GUAM WATERWORKS AUTHORITY

IFB No. 2026-05 NDWWTP Mawar Damage Repairs: Plumbing, Fencing, Process & Controls Response for Inquiries No. 1

This document addresses inquiries regarding IFB 2026-05. It provides clarifications and additional information for informational purposes. In the event that any responses result in modifications to the bid documents, they should be considered as amendments to the original IFB 2026-05.

Sheet: **E10.2.3**
Sheet 942 OF 1075

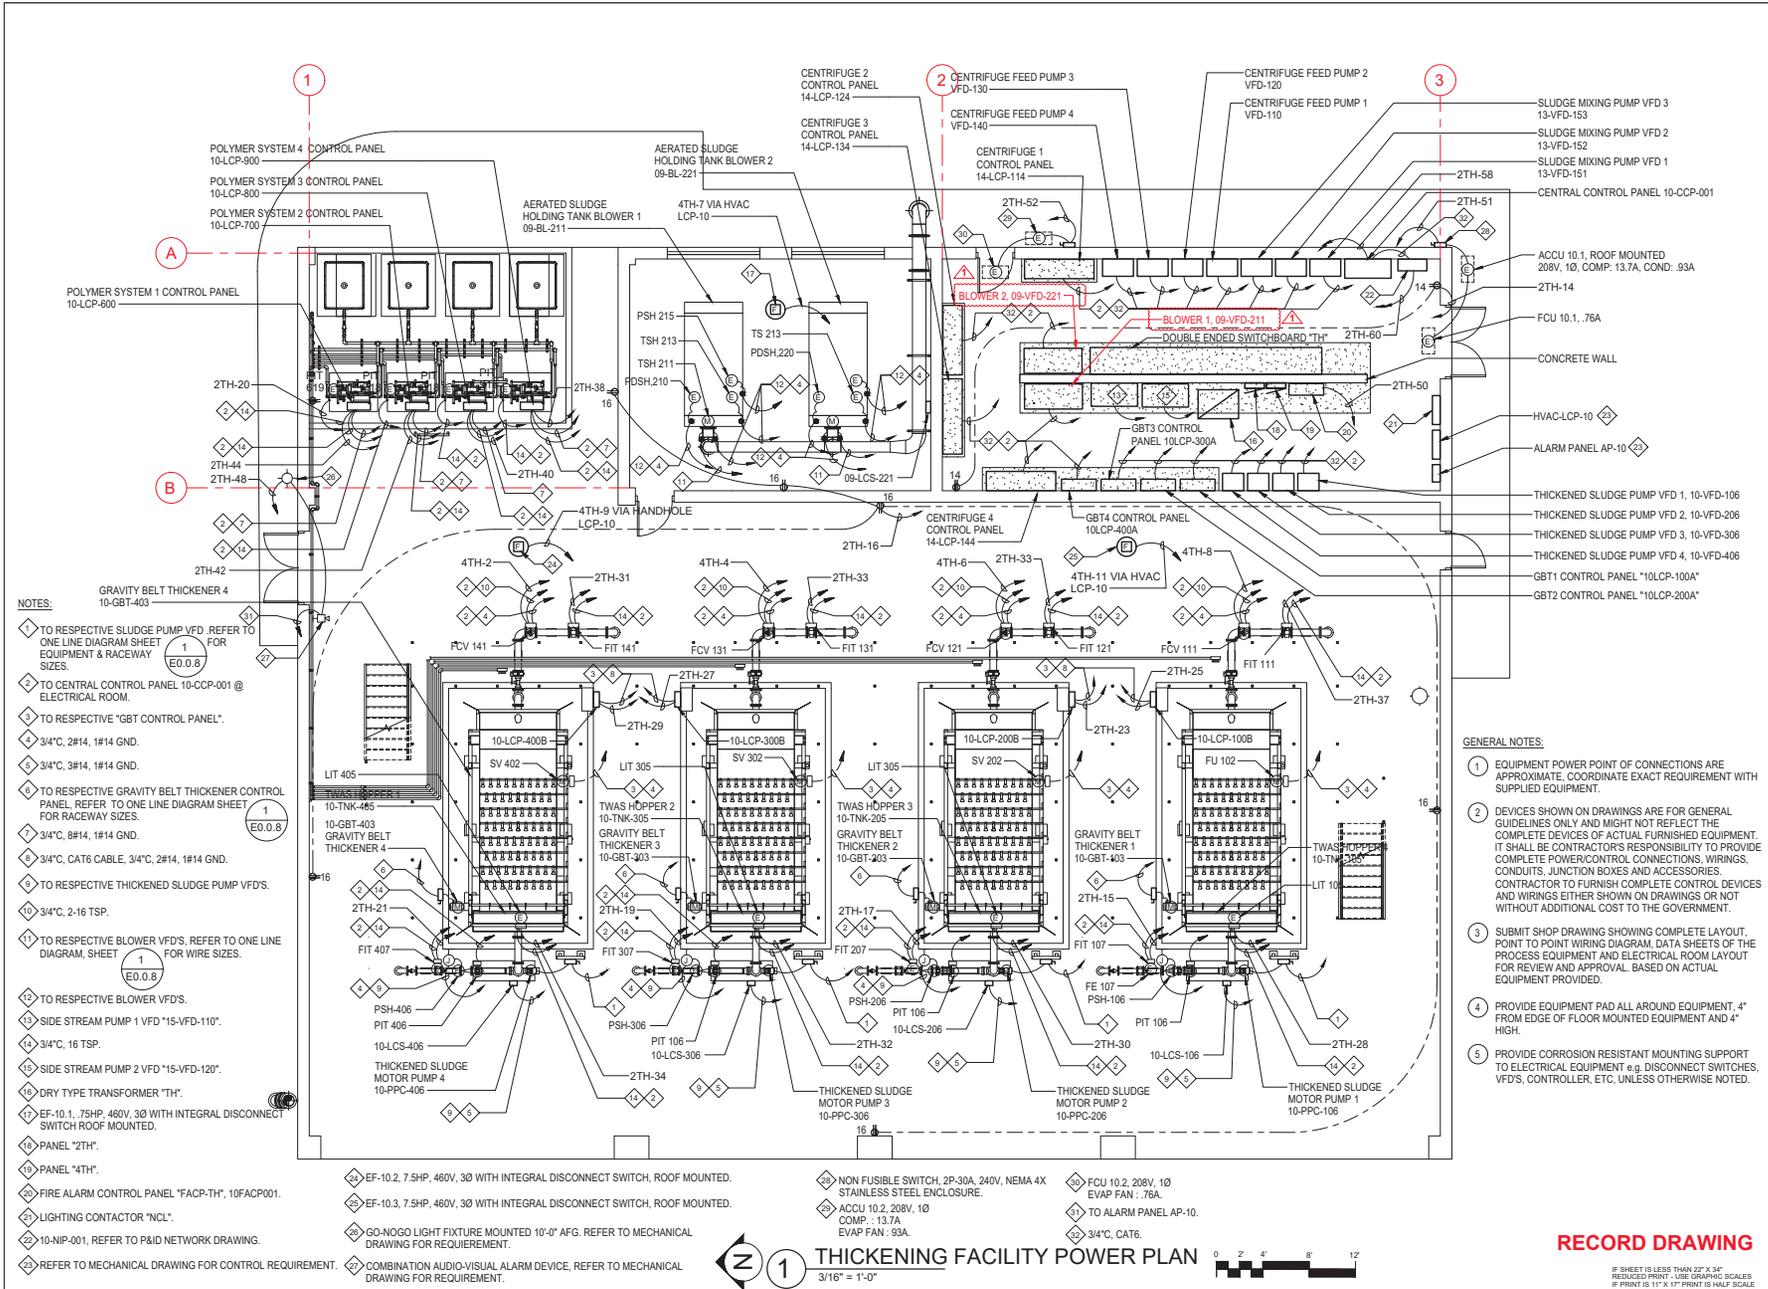
2. For Area 2 – Gravity Belt Thickeners, (1) All components inside enclosure to be replaced? (PLC, I/O, HMI panel, wiring, relays etc.) kindly confirm, (2) Please confirm scopes is replacing 2 units of Gravity belt thickener equipment.	For (2) Gravity Belt Thickeners replace belts, gravity belt thickener feed pump, and all associated electrical components. See attached Record Drawing. E10.2.3

Sheet: **E6.2.1**

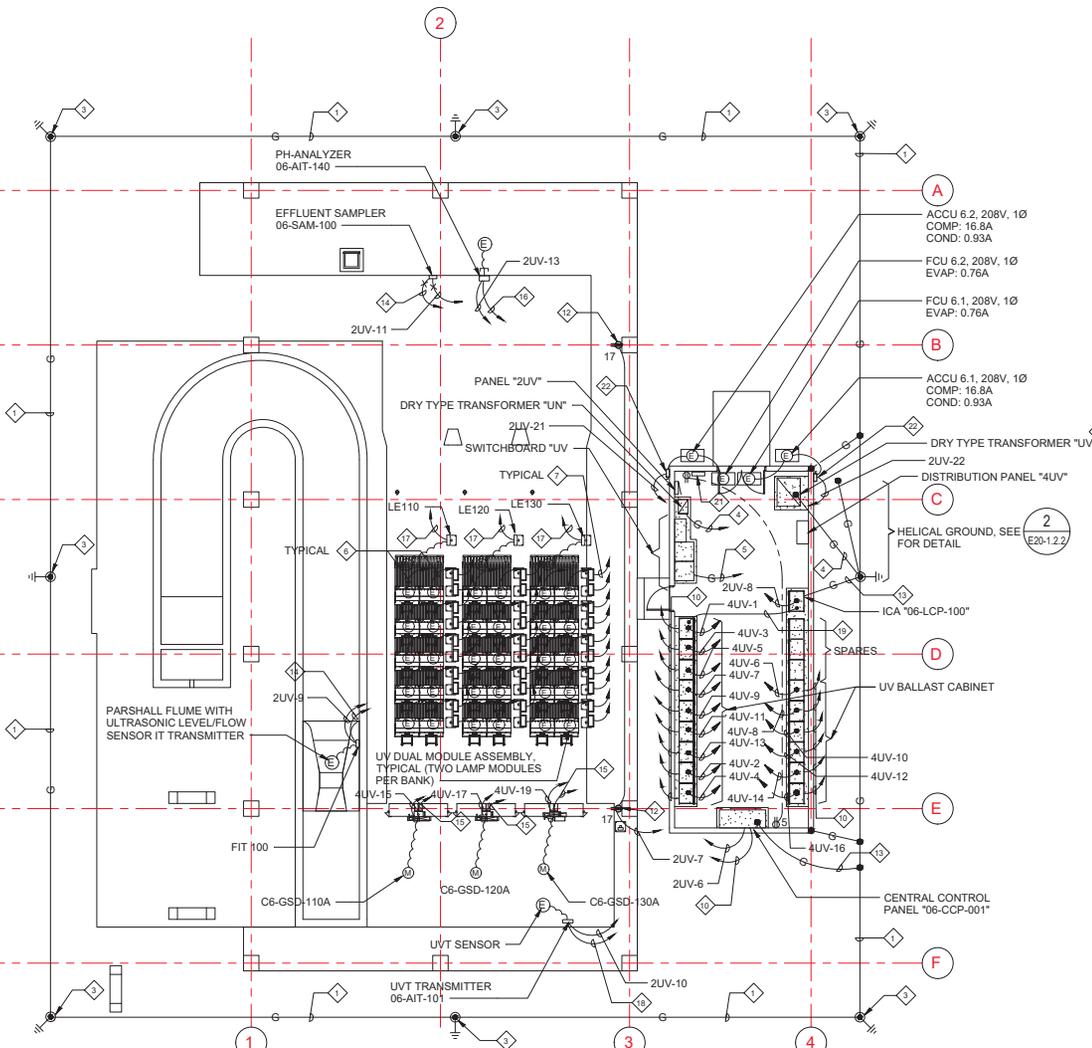
3. UV area – Please share equipment diagram/line electrical diagram.	See attached Record Drawings. E0.0.6, E6.2.1, E6.2.2, E6.2.3, E6.4.1
4. Area 2 – Oxidation – Meter is observed not functioning, please confirm only meter cover is the scopes	Scope should be replacement of the entire meter.
